Project Screening Report — Illustrative Sample

Project X: a fictional rice methane project under Verra's VM0051 methodology

ILLUSTRATIVE · FICTIONAL PROJECT · EACH FINDING FOLLOWS A PATTERN SEEN IN PUBLIC VM0051 DOCUMENTS · TERRAVO · OCTOBER 2026 · SUMMARY + APPENDICES A–E

C2. Before and after the project start, with a control

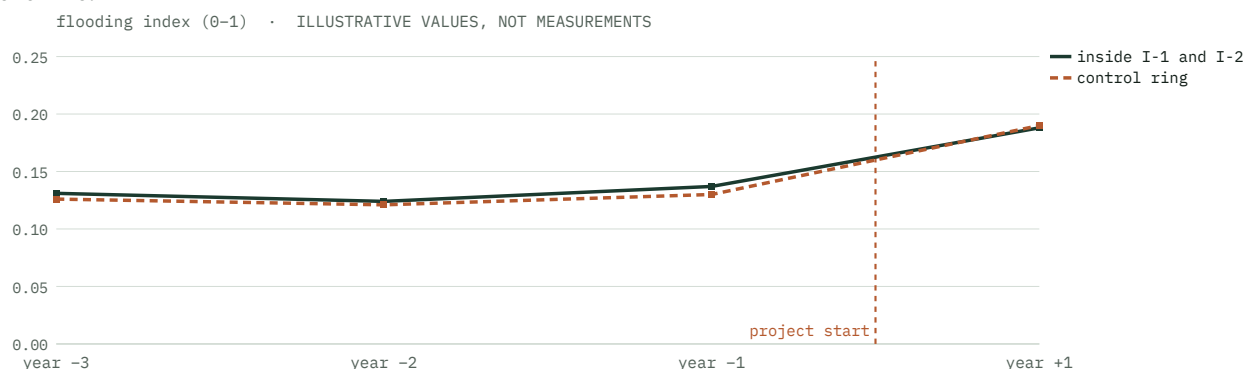
Index: the share of Sentinel-1 passes on which a cropland pixel returned VV backscatter below -16 dB, a proxy for standing water or very wet soil, averaged over cropland inside I-1 and I-2 and in a 30 km control ring. Same satellite and orbit, so the comparison is like for like.

3-YR PRE → POST	CHANGE
Inside I-1 and I-2	0.131 → 0.188	+0.057
Control ring	0.126 → 0.190	+0.064
Difference of changes		-0.007

Both areas moved by about the same amount, so the change is regional (that year's weather and water supply), not a project effect. The difference of changes is inside the year-to-year spread of the inside-versus-control gap before the project (0.003 to 0.007). It is also what we found when we ran this check on a real project: at boundary scale, open radar data does not separate a project's fields from the region around them. A list of enrolled fields (question 9) lets the comparison be run field against neighbouring field. Terravo does not estimate methane from satellite data; tested on fields with ground measurements, such models did not hold up on fields they had not seen.
